Change Bulletin

No: CB002

Description: ECI/HCI New Pressure Gauge Snubber
Open Loop Hydraulic System

Tesco Corporation
6204 – 6A Street SE
Calgary, AB. T2H 2B7
Phone: (403) 692 5700
www.tescocorp.com

Title Kit, Aux Hyd Pres and Tank, G3, 900/1350 ECI	
		File No I-9021-1.ai	Model G3, 900/1350, ECI
Dwg. No I-9021		Rev. 3	Sheet 1 of 2
Date 020404	Drawn MDH	Checked []	Appr. []

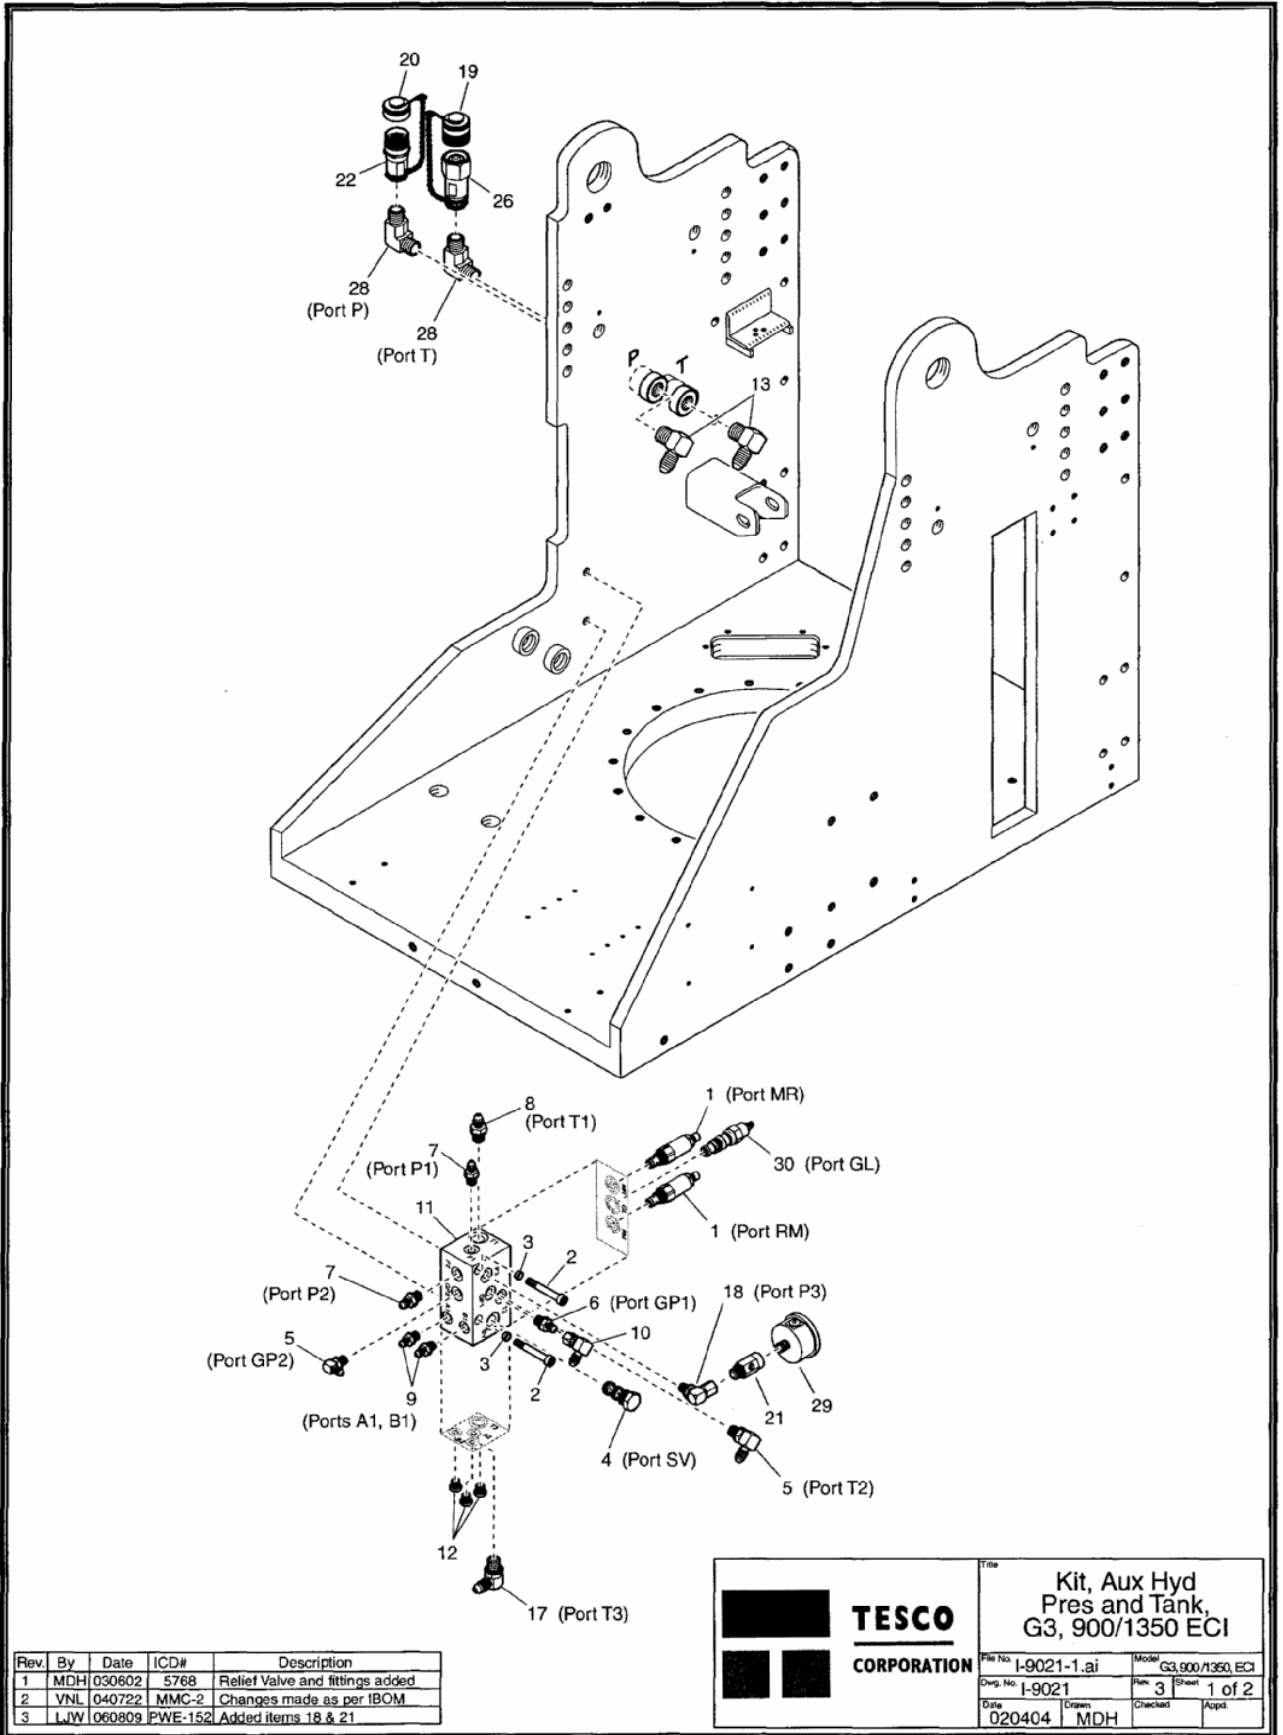
Rev.	By	Date	ICD#	Description
1	MDH	030602	5768	Relief Valve and fittings added
2	VNL	040722	MMC-2	Changes made as per IBOM
3	LJW	060809	PWE-152	Added items 18 & 21

Description	Part No.	Qty.	Illustration, Item No.	Mfg. Date
Snubber, Pressure, 1/4"MNPTx1/4"FNPT, 5000-psi, Brass	720873	1	I-9021, Item 21, ECI I-8480, Item 24, HCI	Revision specific
Fitting, Hyd, 90°Elb, #6MORBx#4FNPT - ECI Only	12353	1	I-9021, Item 18	Revision specific

Title	
		Kit, Pressure Relief Installation, HCI	
File No.	1-8480-1.ai	Model	HCI
Dwg. No.	1-8480	Rev.	3
Date	030303	Drawn	VNL
		Checked	
		Appd.	
		Sheet	1 of 2

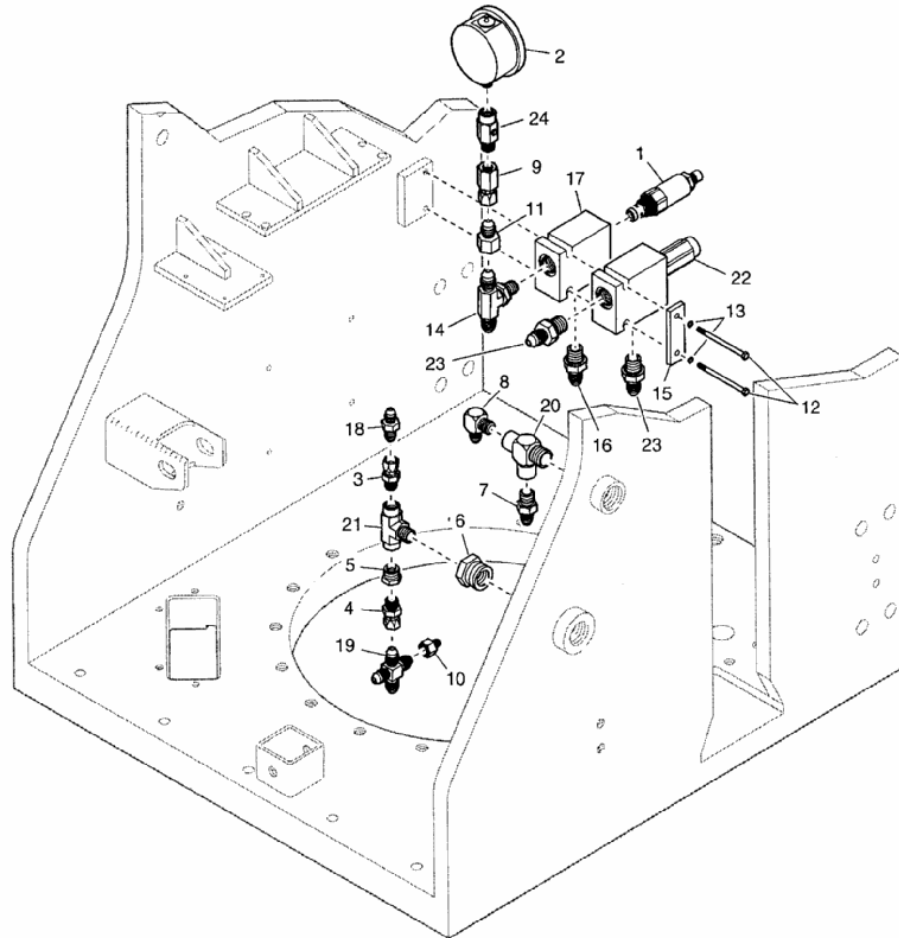
Rev.	By	Date	ICD#	Description
1	MDH	030514	5976	Hoses Removed from IBOM
2	VNL	040309	6267	Added items 22, 23, changed item 12
3	LJW	060809	PWE-152	Added item 24
